UNITED STATES PATENT AND TRADEMARK OFFICE

APPLICATION NO.	FILING DATE	FIRST NAMED INVENTOR	ATTORNEY DOCKET NO.	CONFIRMATION NO.
10/718,068	11/20/2003	Tetsushi Yamaguchi	43521-1200	8665
21611	7590	05/08/2006		
SNELL & WILMER LLP 600 ANTON BOULEVARD SUITE 1400 COSTA MESA, CA 92626			EXAMINER PUNNOOSE, ROY M	
			ART UNIT 2877	PAPER NUMBER

Office Action Summary	Application No. 10/718,068	Applicant(s) YAMAGUCHI ET AL.	
	Examiner Roy M. Punnoose	Art Unit 2877

Figure 1, JP 2002- 221479.

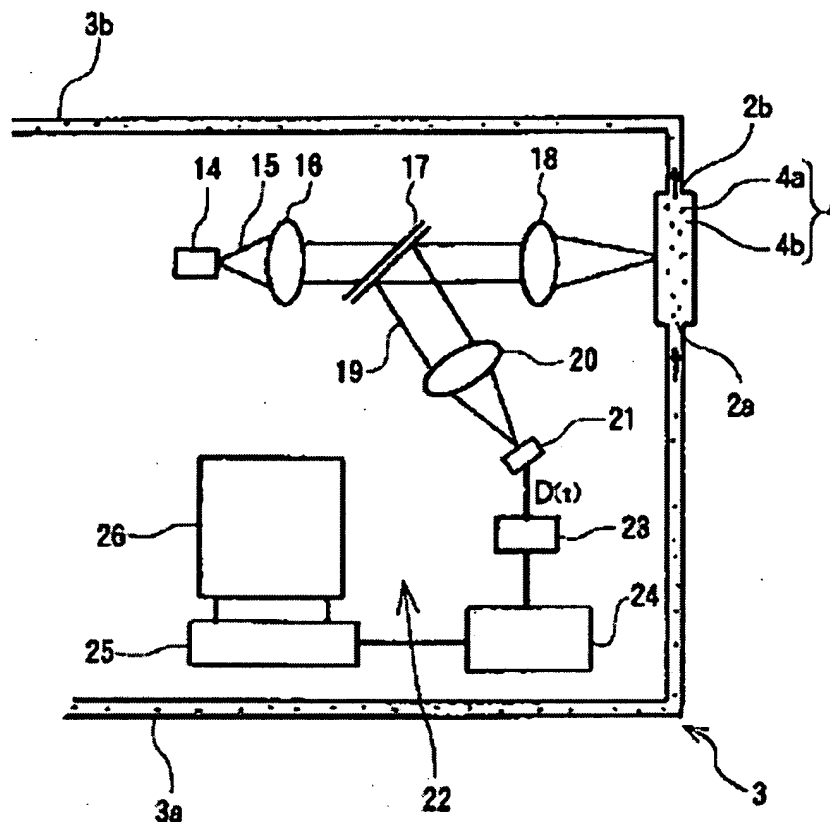
A. Umezawa et al (Umezawa hereinafter) discloses an apparatus comprising a transparent cell 2 for containing a sample 4 containing particles 4a to be analyzed; a laser light irradiating section 14, 15, 16 for irradiating the sample 4 with laser light 15 from outside of the cell 2; a scattering light intensity detecting section 19, 20, 21 for detecting the intensity of light scattered from the particles 4a irradiated with laser light 15; a calculating section 23, 24, 25, 26 for calculating a particle size distribution of the particles 4a based on a fluctuation of the intensity of scattering light measured which occurs due to Brownian motions of the particles 4a (see Figure 1 and the citation of Umezawa prior art by the applicant on pages 1 and 2 of the instant application), said apparatus for measuring dynamically the particle size/diameter distribution of a sample under test so that the concentration of particle(s) of a

B. However, Umezawa does not teach of a noise reducing section comprising a region to be irradiated with laser light of at least one of outside surface and inside surface of the cell, the region being inclined at a predetermined angle with respect to the optical axis of the laser light to prevent any noise-causing light reflecting back from the cell wall, in the reverse direction of the irradiating laser light source, in the apparatus for measuring dynamically the particle size/diameter distribution of a sample under test so that the concentration of particle(s) of a specific size or diameter can be determined for the purpose of controlling the concentration of the particle of a desired size in said sample.

FIG. 2

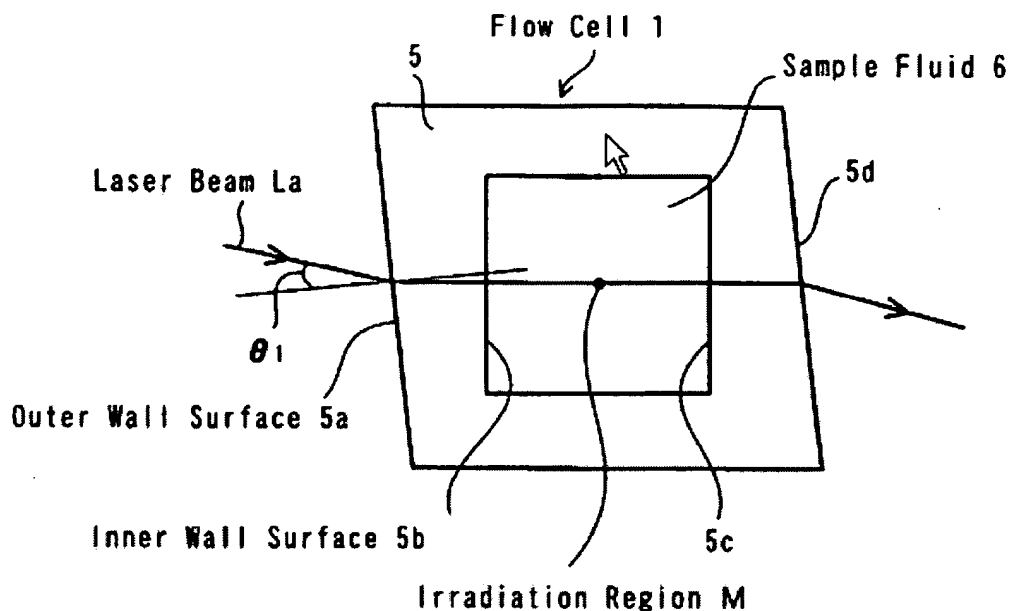
- C. Matsuda teaches of an apparatus (see Figure 1) comprising a flow-cell having a noise reducing region (see the region where the laser beam La is incident on the wall of the flow cell in Figure 2) comprising a region to be irradiated with laser light La of at least one of outside surface 5a and inside surface 5b of the flow cell 1, the region being inclined at a predetermined angle θ_1 with respect to the optical axis of the laser light La (see Figure 2) to prevent any noise-causing light reflecting back from the cell wall, in the reverse direction of the irradiating laser light La, said flow cell in an apparatus for obtaining particle information including particle diameter, the particles suspended in a fluid passing through said flow cell (see col.1, lines 8-13).

- B. Matsuda teaches of a transparent flow-cell 1 that has four walls (see Figure 2) with an incident and egressing wall for laser light transmission that is non-traverse to the optical axis of the laser light (see col.4, lines 40-48) to prevent any noise-causing light reflecting back from the cell wall, in the reverse direction of the irradiating laser light La, said flow cell in an apparatus for obtaining particle information including particle diameter, the particles suspended in a fluid passing through said flow cell (see col.1, lines 8-13).

FIG. 1

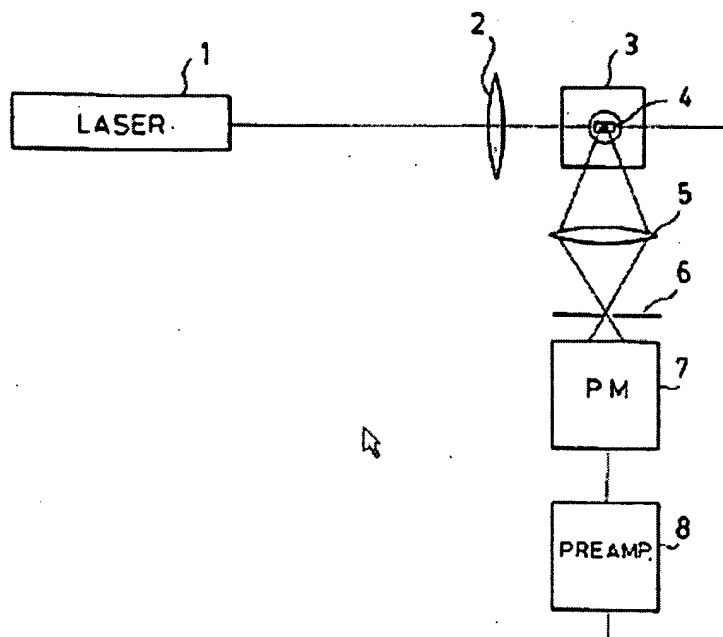
18. Claim 7 is rejected for the same reasons of rejection of claim 1 as detailed above. In claim 7, with regard to the recitation "to reduce any scattered light from defects in the surfaces of the planar wall," the reduction of noise from scattered light from defects on the surface of the planar wall of the cell is a result and a benefit of directing the light at the cell wall surface at a predetermined angle that is greater than a perpendicular crossing the optical axis of the flow-cell.

This benefit is inherent in Matsuda's teaching because Matsuda's flow-cell has a noise-reducing region which is inclined at a predetermined angle with respect to the optical axis of the laser light to prevent any noise-causing light reflecting back from the cell wall.
